RESPONSE TO REQUEST FOR ADDITIONAL INFORMATION

APR1400 Design Certification

Docket No. 52-046

RAI No.: 504-8628
SRP Section: 12.03 – Radiation Protection Design Features
Application Section: 9.1.3.2.3
Date of RAI Issue: 07/11/2016

Figure 9.3.4-1 Chemical and Volume Control System Flow Diagram (7 of 7)

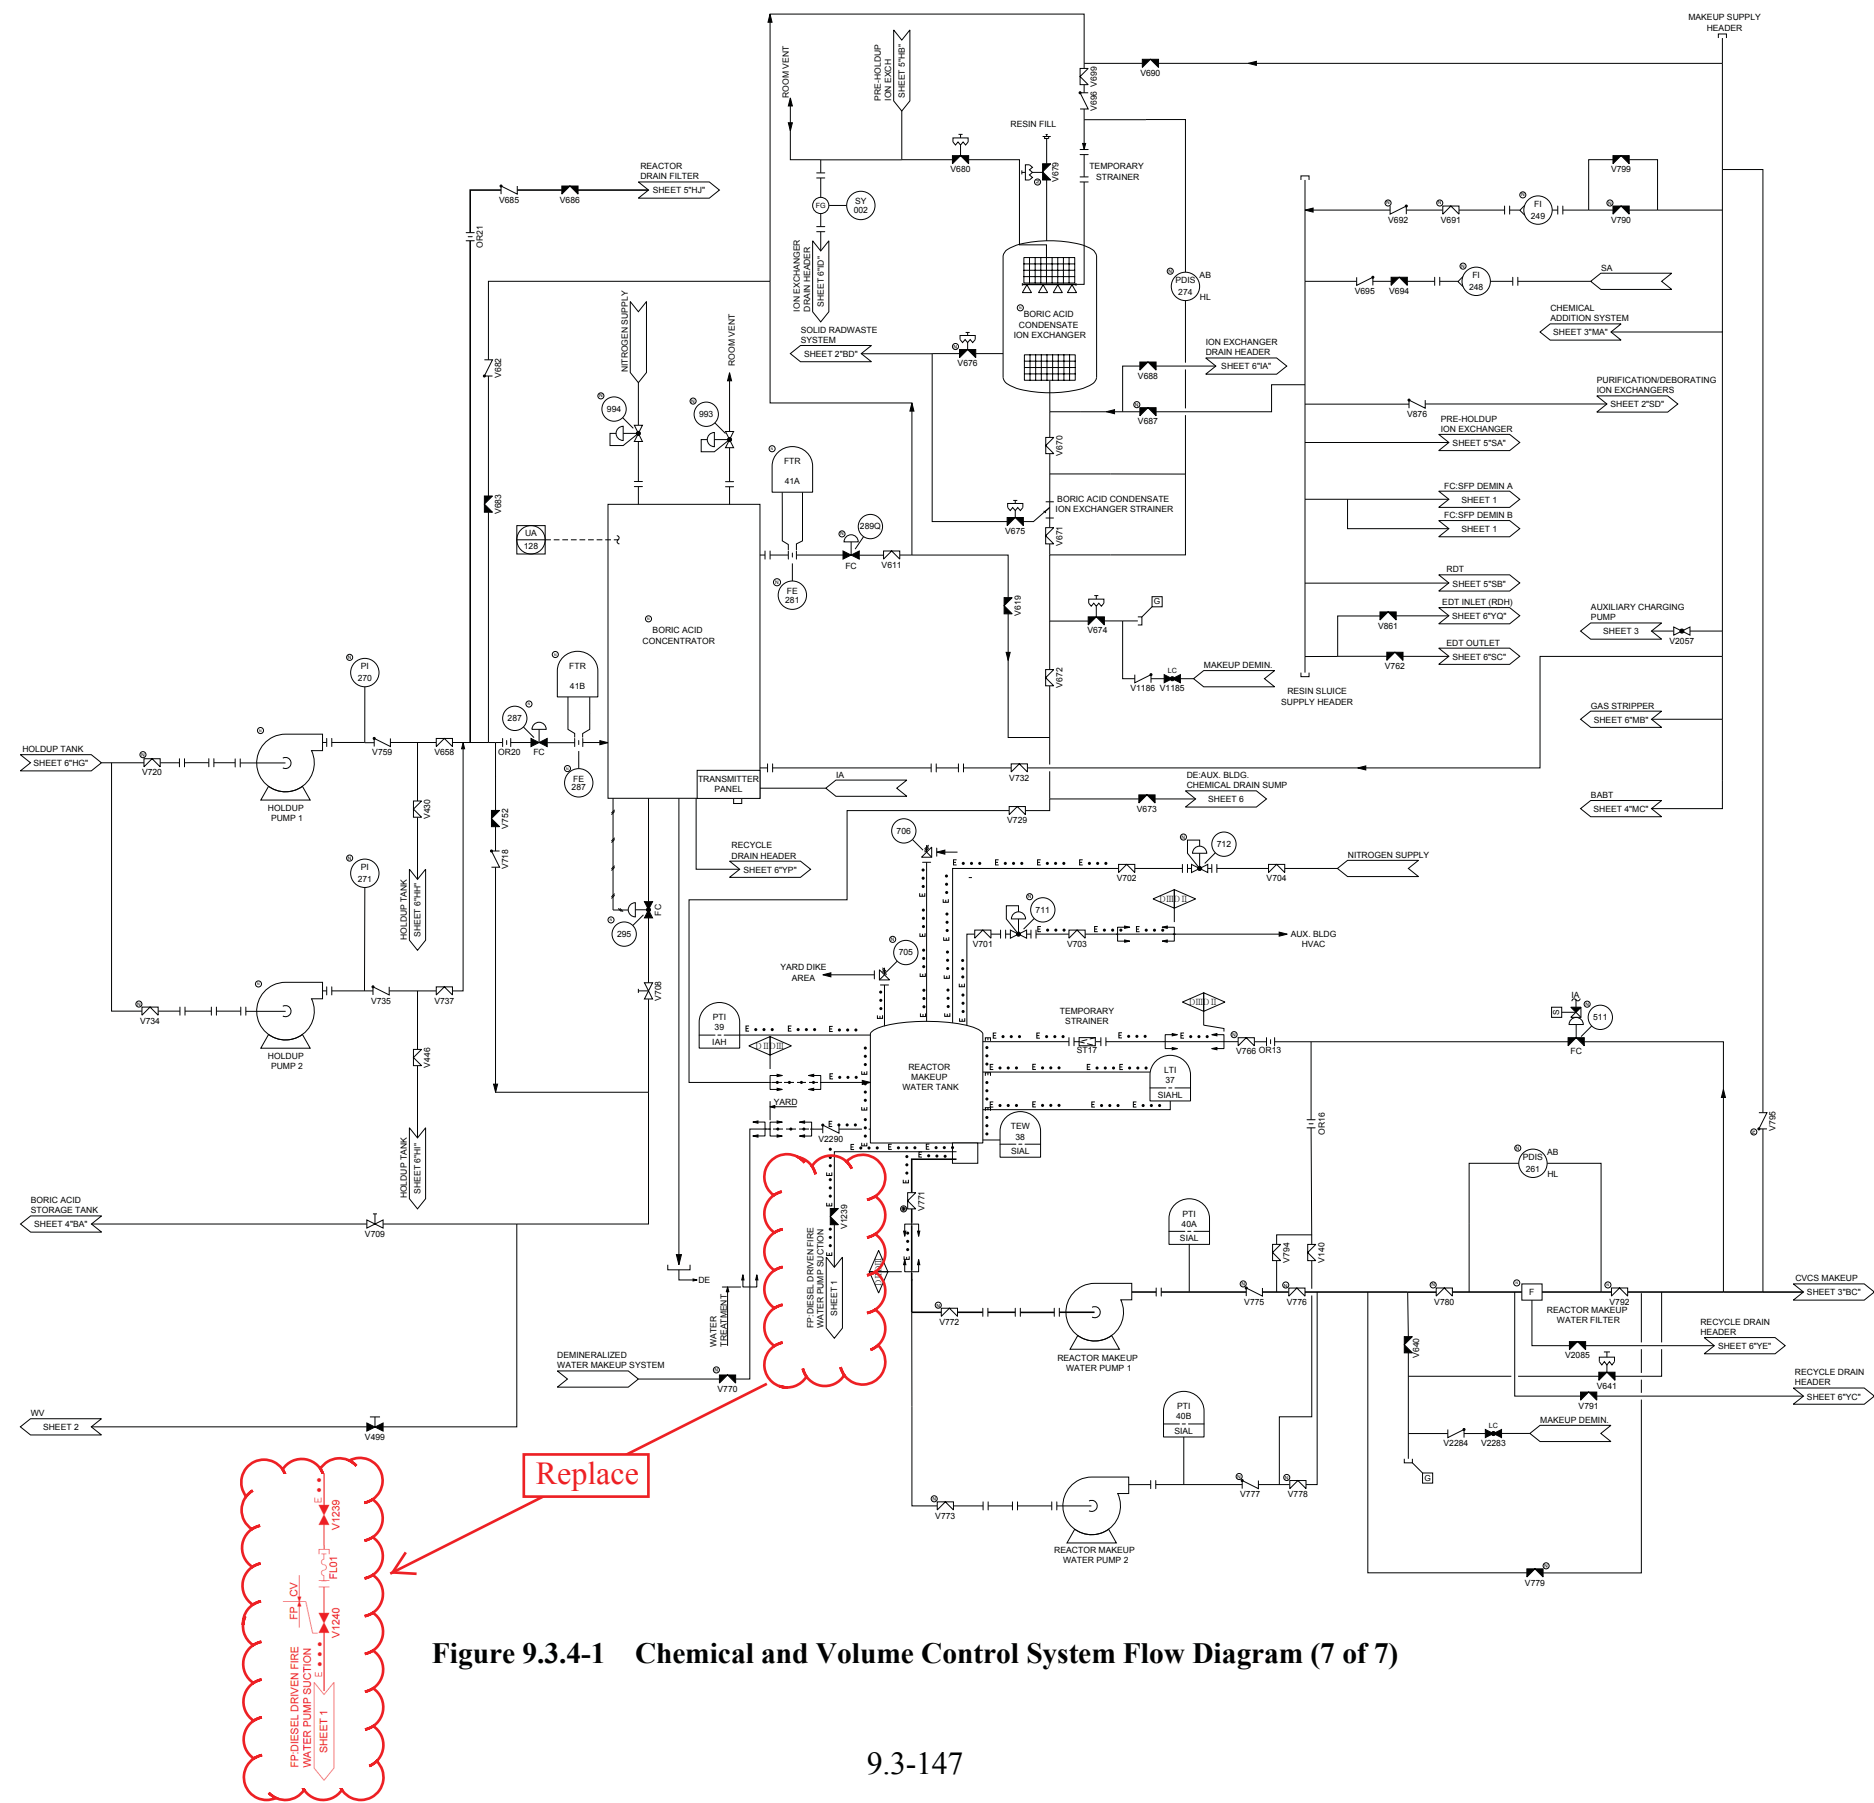
However, in reviewing the boric acid concentrator package and associated flow diagrams for the chemical and volume control system, in trying to resolve concerns associated with RAI 8353, Question 12.02-21, staff identified a piping connection between the reactor makeup water tank (RMWT) and the fire protection system (as shown in DCD Figure 9.3.4-1), with only one diaphragm valve separating the RMWT from the fire protection system. The applicant indicated in a conference call that this line was only used for the emergency containment spray backup system, during accident conditions, and there are not high pressures associated with the valve, therefore, the applicant indicated that the valve is not expected to be operated frequently and is not expected to leak. However, operating experience indicates that diaphragm valves have a tendency for through leakage, especially as the valves age.

In order to meet the criteria specified in DCD Section 9.1.3.2.3 and the above guidance, the applicant is requested to either 1) revise the design of the connection between the RMWT to the

fire protection system to either remove the permanent line or 2) if the applicant prefers to retain a permanent connection, please revise the design to provide a minimum of two barriers, including one that can be a pressure differential, and include instrumentation for prompt detection and control of cross-contamination.

The water supply connection from the RMWT to the ECSBS will be modified according to RG 4.21, "Minimization of Contamination and Radioactive Waste Generation: Life-Cycle Planning," Section A-1.

The modification will be incorporated in DCD Tier 2, Figure 9.3.4-1.

DCD Tier 2, Figure 9.3.4-1 will be revised as indicated in Attachment.
